V2500-A1/A5/D5 SERIES PROPULSION SYSTEMS SERVICE BULLETIN

This document transmits Revision 1 to Service Bulletin EV2500-72-0472 and Revision 1 to the Supplement

V2500-ENG-72-0472

ENGINE – HP COMPRESSOR DISCS (STAGES 3-8) – INTRODUCTION OF REVISED DAMPER WIRES1. Planning InformationA. Effectivity

HP Compressor Stage 6 Damper Wire Family Tree

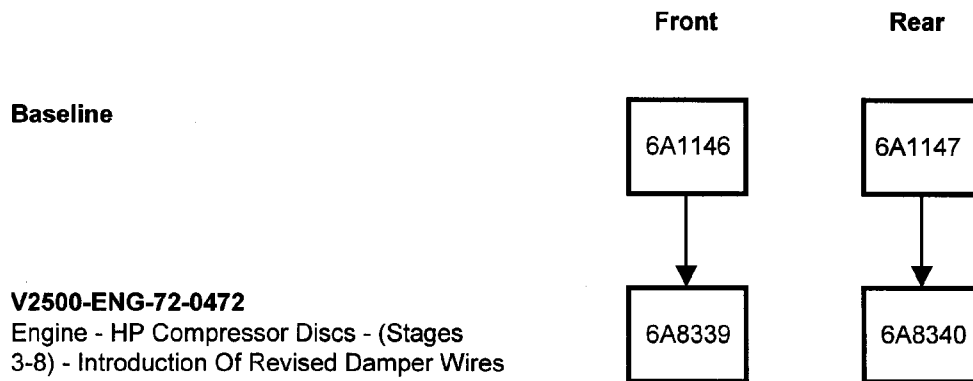
- (a) Revised HP Compressor Stage 6, 7 and 8 Damper Wires are introduced, similar to the existing items except at the overlapping position, where the profile has been changed from a vertical cut to a 45 degree chamfer.

For the correct Assembly Instructions refer to Engine Manual, Chapter/Section 72-41-10, Assembly.

HP Compressor Stage 7 Rear Damper Wire Family Tree

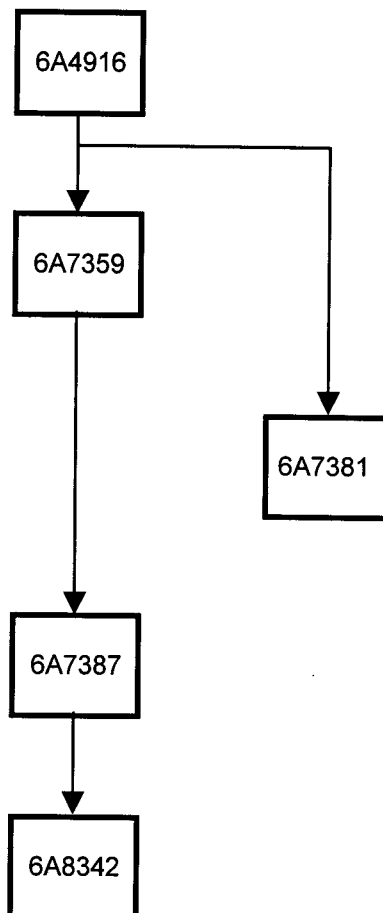
Engine - HP Compressor Discs - (Stages
3-8) - Introduction Of Revised Damper Wires

HP Compressor Stage 8 Front Damper Wire Family Tree
All Engines
Baseline
V2500-ENG-72-0289

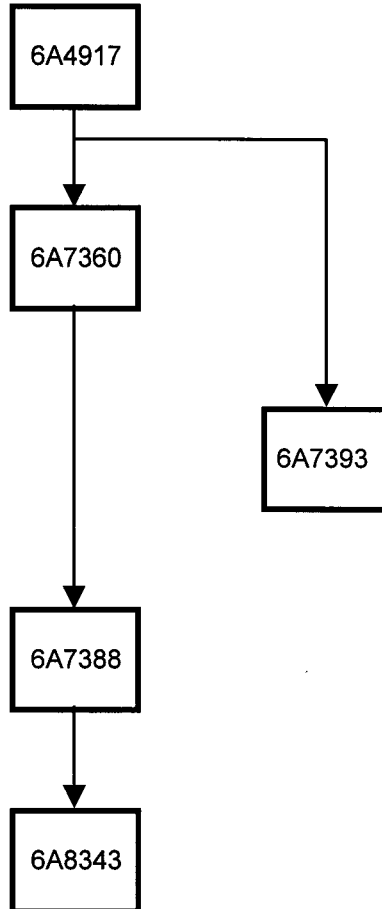
Engine - HP Compressor Discs - (Stages
3-8) - Introduction Of Revised Damper Wires
